Eastern Regional Power Committee

Sub: Minutes of the 146th PCC meeting held on 23.04.2025

MINUTES OF 146TH PROTECTION COORDINATION SUB-COMMITTEE MEETING HELD ON 23RD APRIL 2025 AT 10:30 HRS THROUGH MS TEAMS

Disturbance in Capital City of Ranchi on 15th April 2025

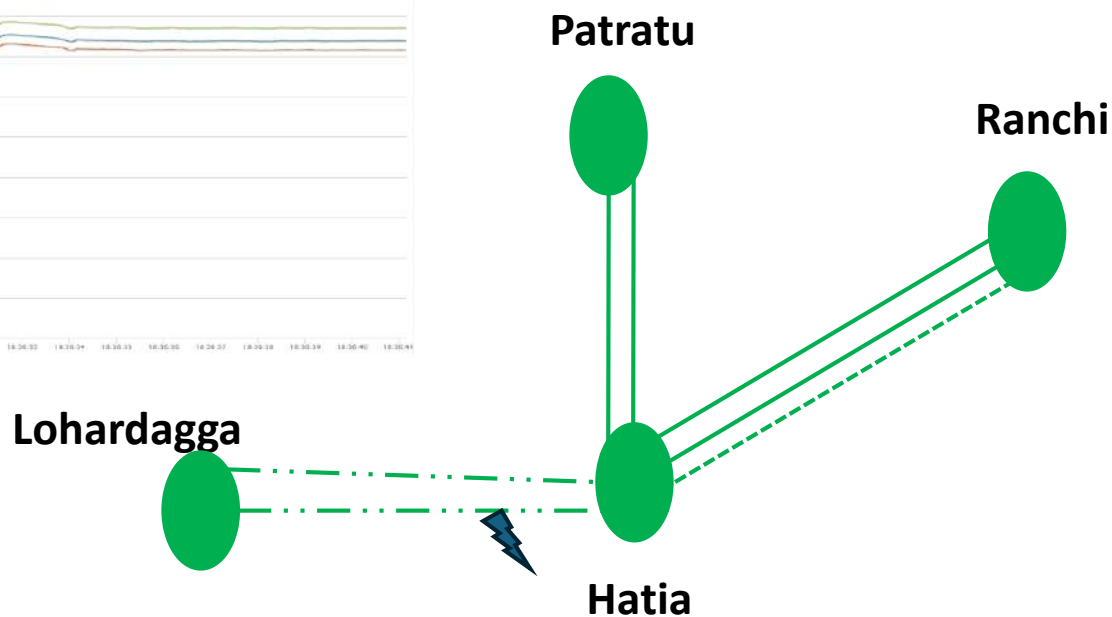
- Fault in Zone-1 of idel charged Lohardagga line but as CT polarity was reverse it sensed the forward fault of line in Zone -4.
- As Zone-4 time is 500 Ms so fault persisted till 500 Ms and all lines from remote end also tripped in Zone-2 time resulting to Load loss.
- **How CT Polarity reversal was not checked/ missed .**
- **Busbar protection is also unhealthy at Hatia.**

He further advised ERPC representative to share communication to concerned official of JUSNL regarding periodic monitoring of healthiness of protection equipment.
